Subject: Re: Cuddesdon Cross

I risk sounding rather pompous.....but I ought to try and clarify the risks involved with foundation design. If a consulting engineer does it (as you know, my preference), he is liable and will have insurance if anything goes wrong - like the leaning gas governor housing at the entrance to Parkside. Gilbert and I are no longer qualified - even if we were, our insurance would not cover us to undertake structural design! Contractors generally hold 'All Risks' insurance but this doesn't always cover 'design'. I will show a provisional foundation on the drawings and say 'modify in accordance with site conditions' which is an instruction to the

19 Jan 2015.

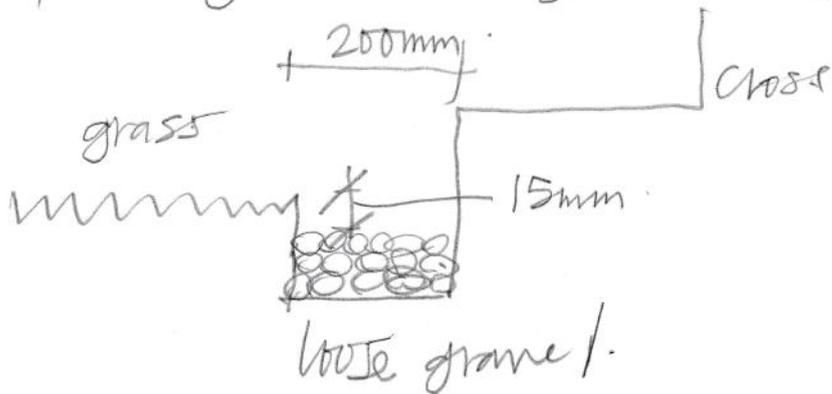
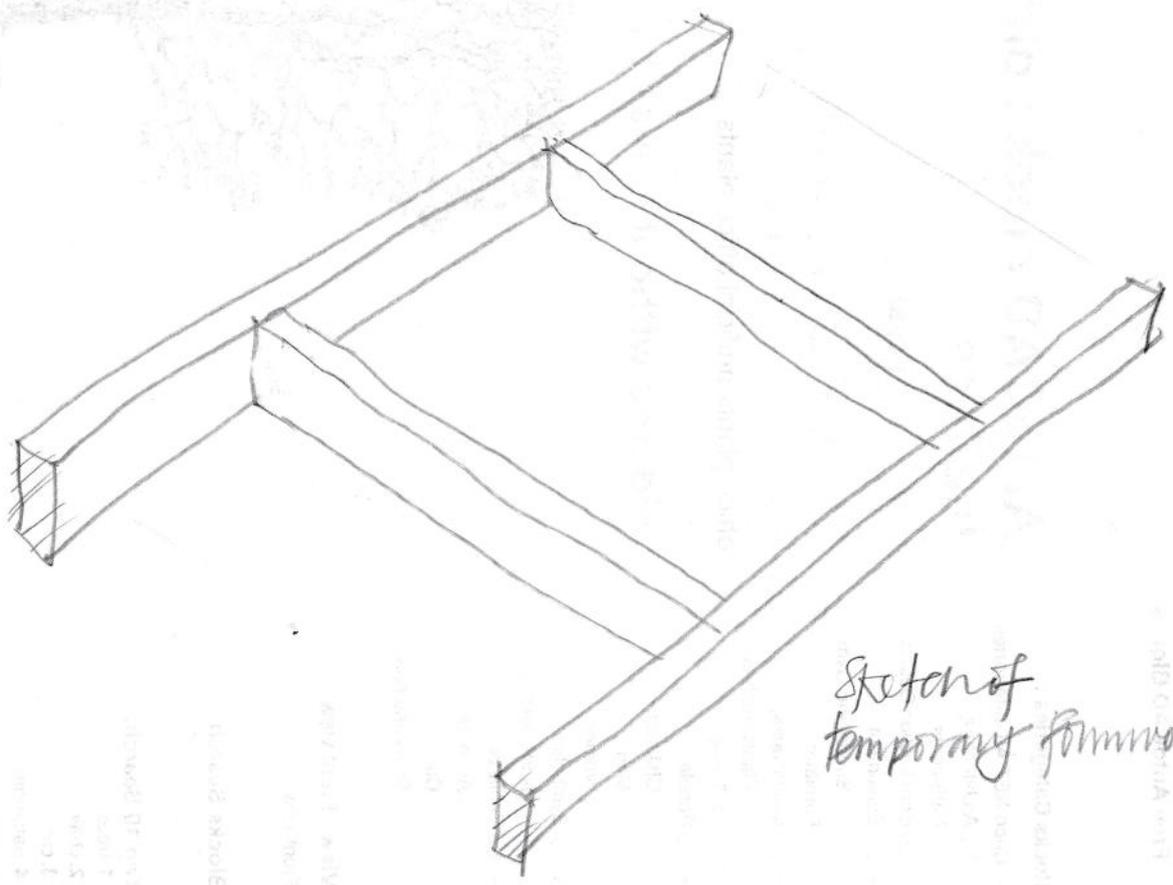
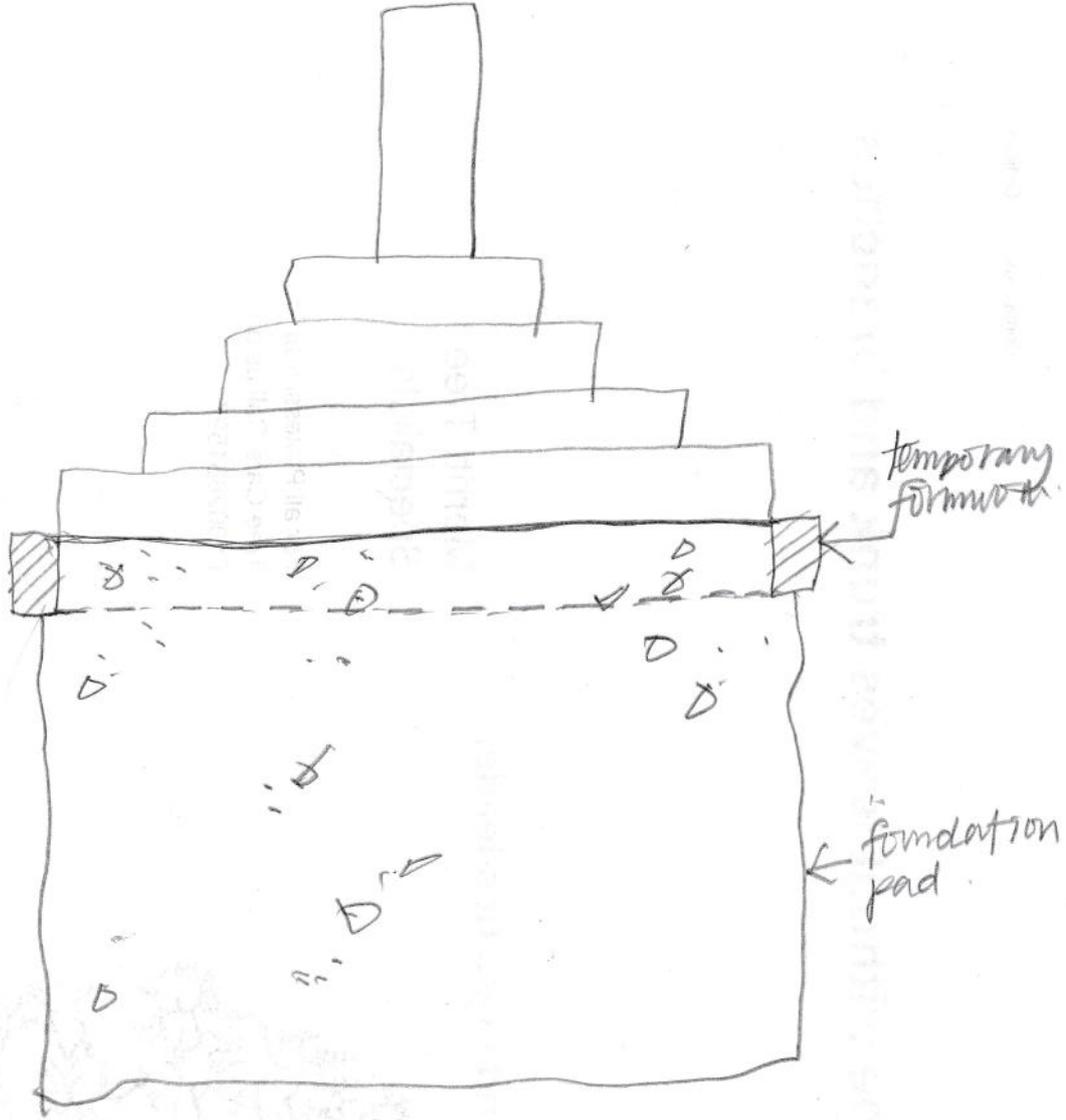
discussed Gilbert/Robert

Sketch of temporary formwork

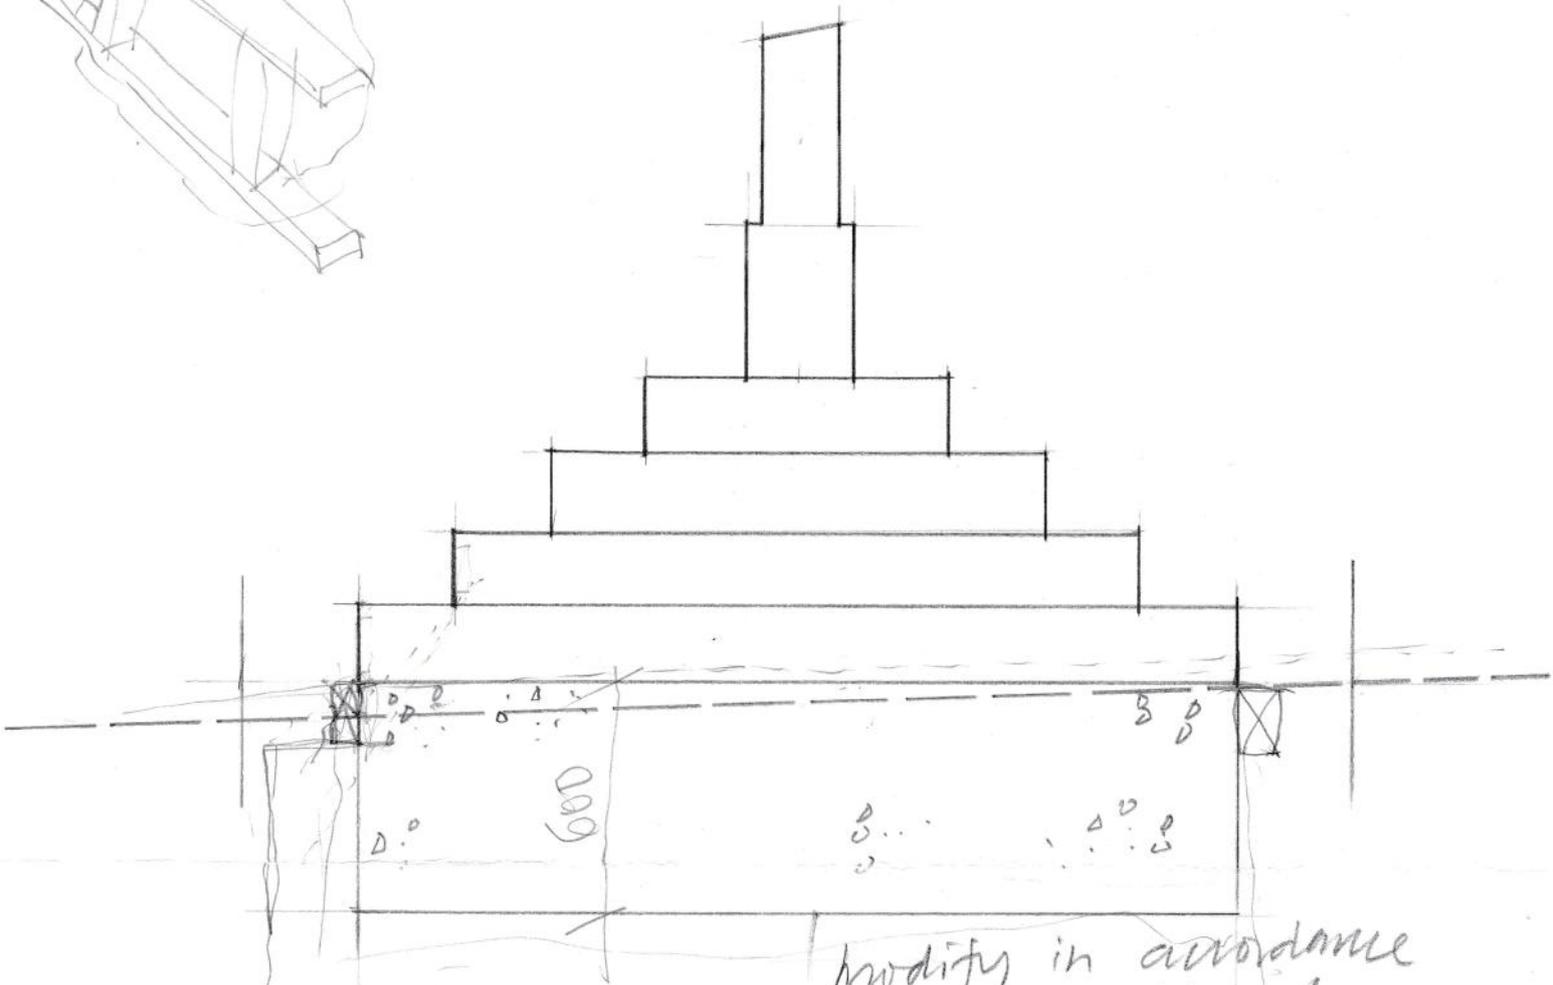
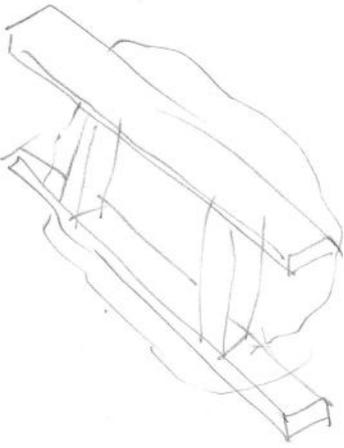
BUT maybe Elizabeth Beasley suggests:

concrete mix
ST2 or GEN1

modify in accordance
with site conditions

+ Enlarged trim detail

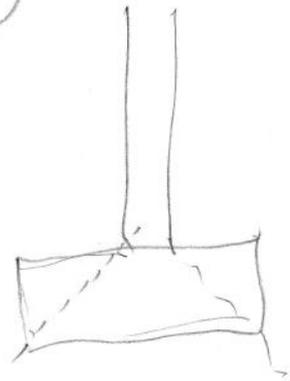
Inscribed block 200 x 550 mm
allow 25mm margin - plaque: 150 x 550 mm
